**TCP/11/16(476) – 16/01865/FLL – Formation of access road on land 60 metres East of Kinwreaton, Brucefield Road, Blairgowrie**

# NOTICE OF REVIEW

This document has been prepared for inclusion in the submission to PKC Local Review Body in relation to the refusal of planning application 16/01865/FLL.

**RE - PKC 16/01865/FLL – PLANNING APPLICATION REFUSAL FOR FORMATION OF ACCESS ROAD AT LAND 60M EAST OF KINWREATON, BRUCEFIELD ROAD, BLAIRGOWRIE**

SITE BLOCK PLAN			
New Access Road to Residential Land at Welton Holt, Rosemount, Blairgowrie for Mr & Mrs Bruce & Kirsty Thomson		date 22.10.2016	drawn GD
		scale 1 : 500	revision
		job number 665	drawing number L02
		revision C

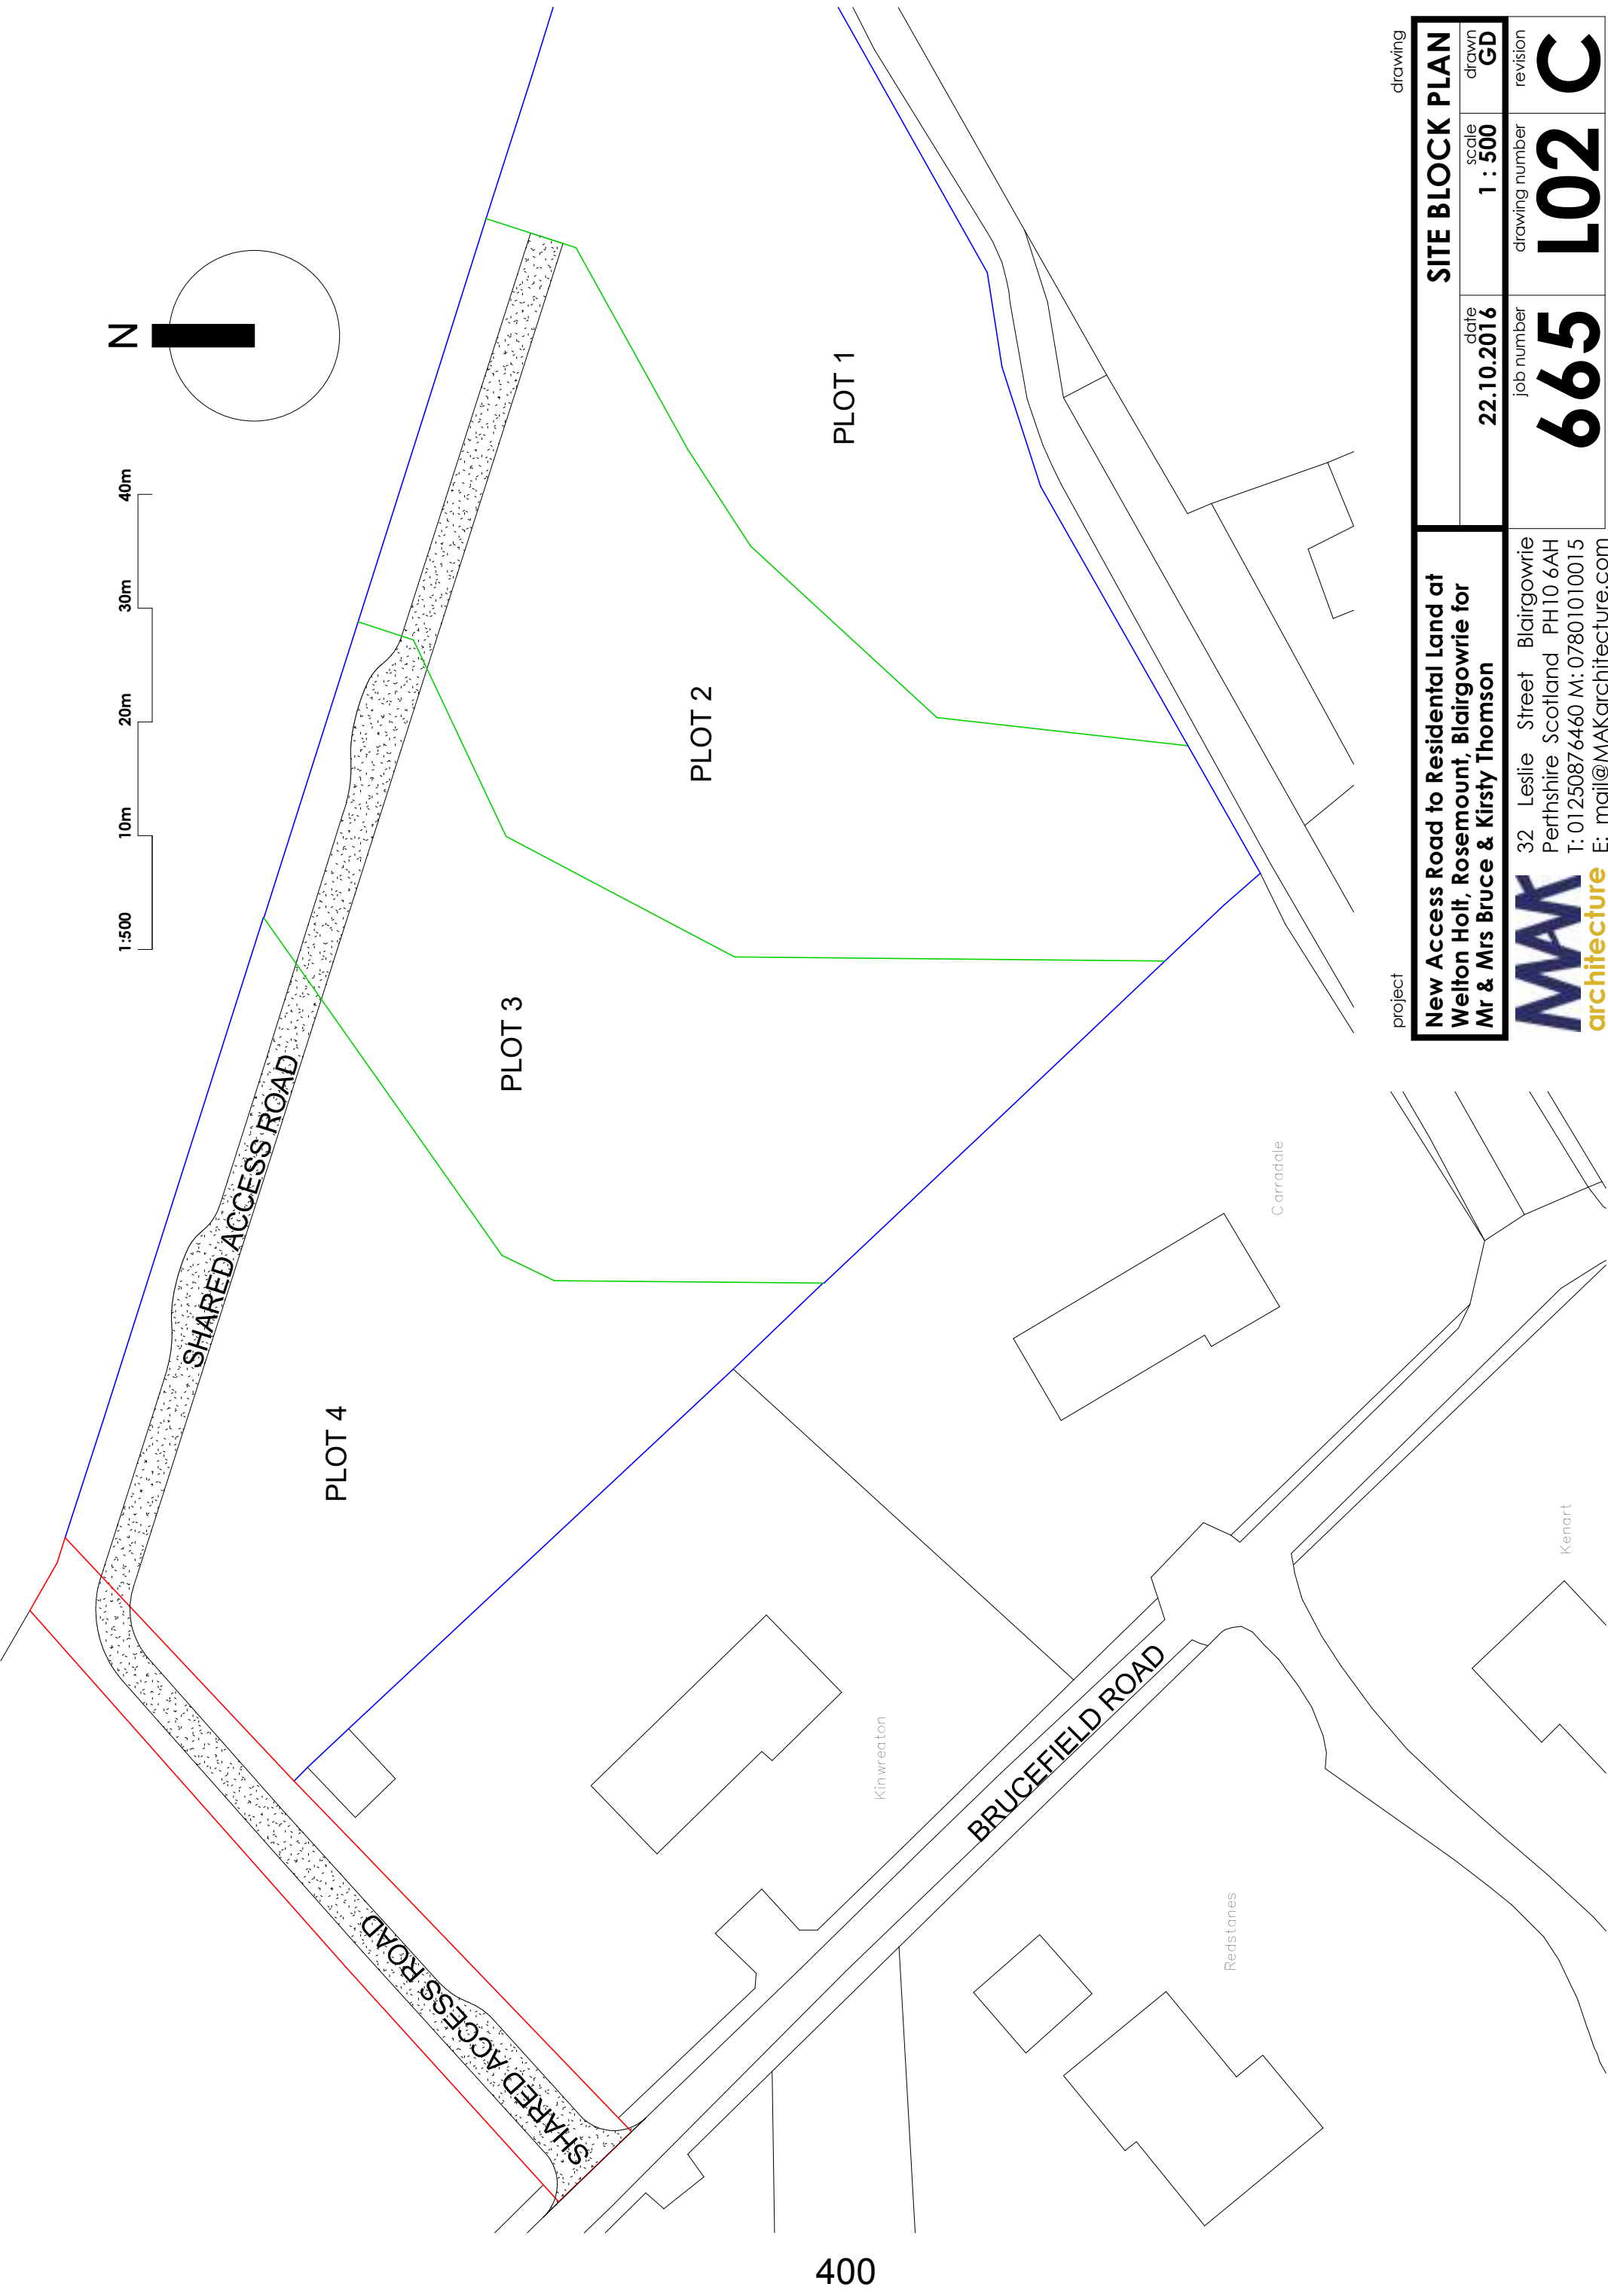
f) The determination took no account of revised drawing 665L03C dated 14.12.2016, prior to determination, which Transport Planning agreed answered much of their consultation response.

9. In the section 'roads and access' there is mention of issues with passing places, road widths and emergency vehicle access. This takes no cognisance of the revised road layout submitted to the planning department and accepted by roads and transports some months prior to the delegated report. Also, it still refers to the 30mph visibility splays of 2.4x46m when Niall Moran Transport Planning Officer had agreed to accept reduced visibility splay of 2x25m. The concern raised about access to housing site H62 could be dealt with in the same manner of the original consent 12/00678/FLL for Mr Thomson's residential site. That required the installation of bollards to prevent vehicular access beyond the site.
